SUNDRY NOTICES AND REPORTS ON WELLS (DO NOT USE THIS FORM FOR PROPOSALS TO DRILL OR TO DEEPEN OR PLUG BACK TO A DIFFERENT RESERVOIR. USE "APPLICATION FOR PERMIT" (FORM C-101) FOR SUCH PROPOSALS.)		WELL API NO. 30-005-29027

Cano Petro Of New Mexico
Cato San Andres #588
API: 30-005-29027
Chaves County, New Mexico

Plug And Abandonment Procedure

Cato San Andres #588

Proposed Wellbore Diagram

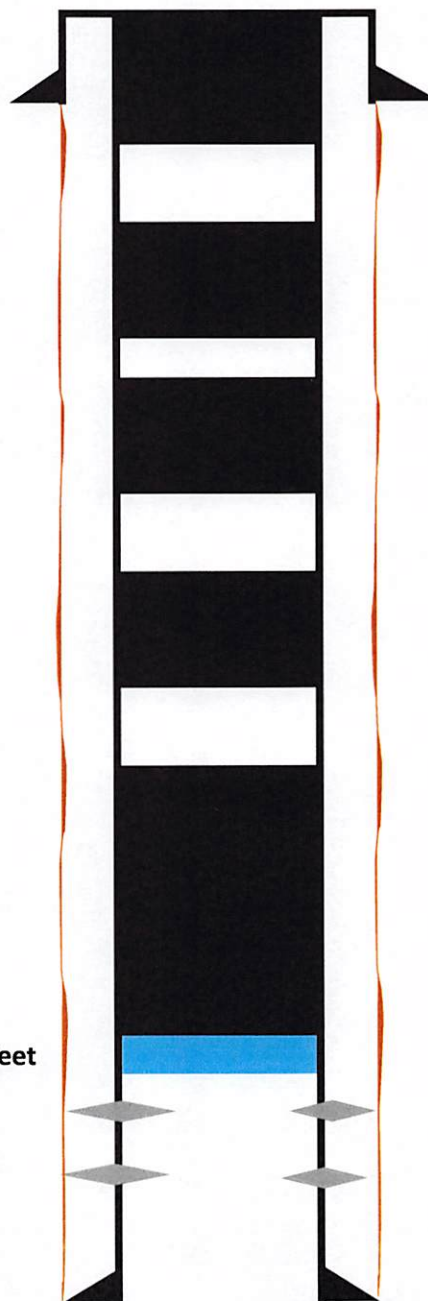
APPROVED WITH CONDITIONS

Perf & Sqz all
shoes.

Adhere to NMOCD
COAs attached.
